■VF-nC3 software version up information

■Errata sheet

This errata sheet provides updated information on VF-nc3 Instruction Manual E6581597①(Attached) and E6581595① (Detailed).

■Examples of connections when an external power supply is used (page B-11)

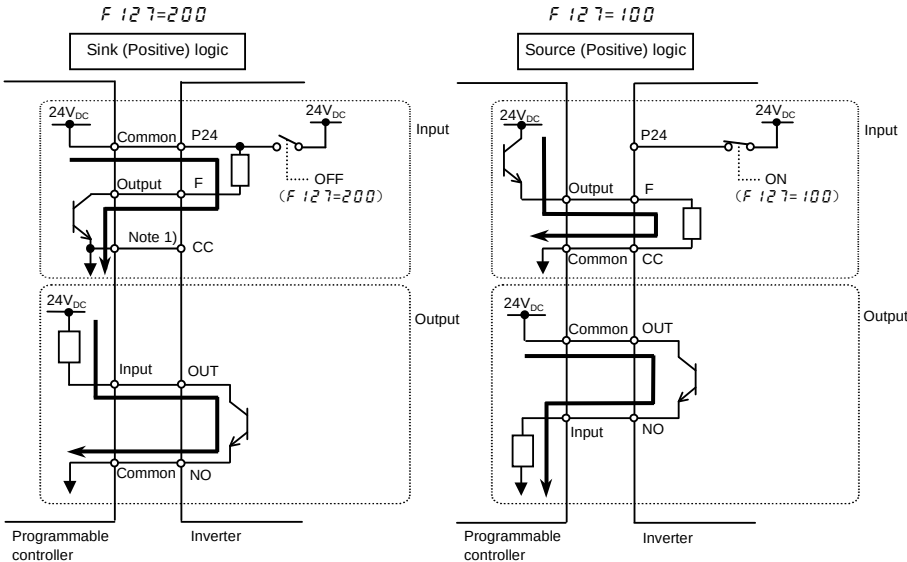
Updated information on VF-nc3 Instruction Manual E6581597①(Attached) and E6581595①(Detailed).

Note 1) Be sure to connect 0V of external power supply and CC terminal of the inverter.
